Development Review Committee Comments | 10/4/2022
Case PLAT22-0028
Antinone Addition (7200 Mid-Cities Boulevard)

WRITTEN STATEMENT OF CONDITIONS

CIVIC CENTRE ADDITION
LOT 2 AND LOT 3, BLOCK 1

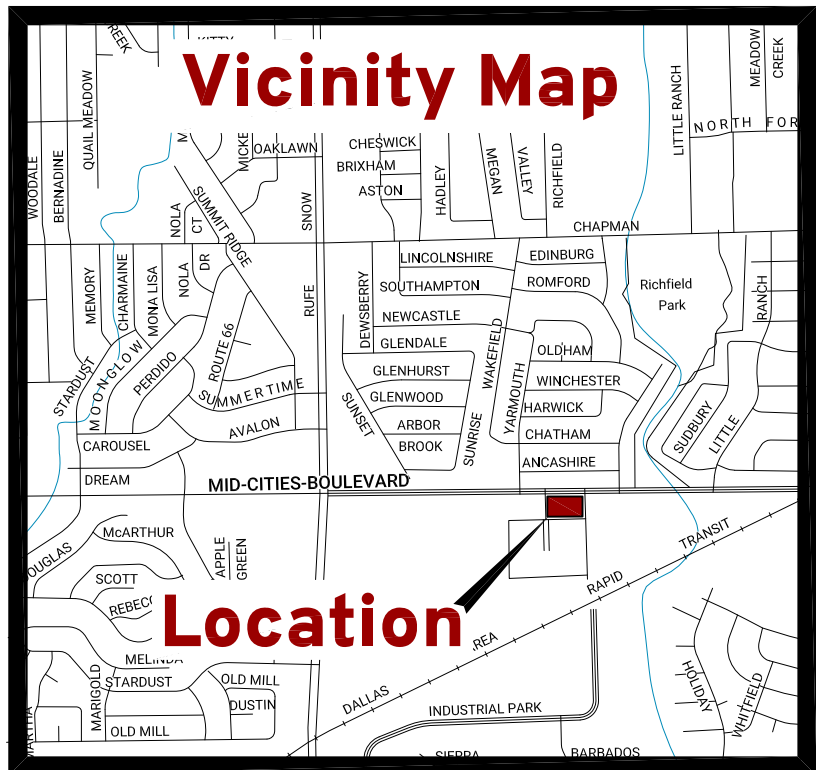
Add and label a sight visibility easement (15 ft by 70 ft) at all street corner intersections

On the civil plans, there are areas adjacent to the front property line where the proposed sidewalk encroaches into the property. In these areas, add a sidewalk easement to the plat.

At each street intersection corner, add a 10 ft x 10 ft sidewalk and utility easement, or provide a 10 ft x 10 ft corner clip ROW dedication.

Easement should be measured from property (ROW) line rather than curb. Revise reference in note.

Add the following notes to the drawing.

- No above ground franchise utility appurtenances are allowed in the fronts of the properties.
- The easements indicated on this plat are for the purpose of constructing, using, and maintaining public utilities including underground conduits, manholes, pipes, valves, posts, above ground cables, wires or combinations thereof, together with the right of ingress and egress to operate and maintain the public utilities.
- Driveway access to Mid-Cities Boulevard is not permitted for the property.

Recommended to remove email address from plat drawing

The County clerk recording block may be removed from the drawing. Plats are recorded electronically and the block is not necessary

Add the City case number near the bottom right corner of the drawing (Case PLAT22-0028)

Revise to Lots 1 and 2, Block 2, Antinone Addition
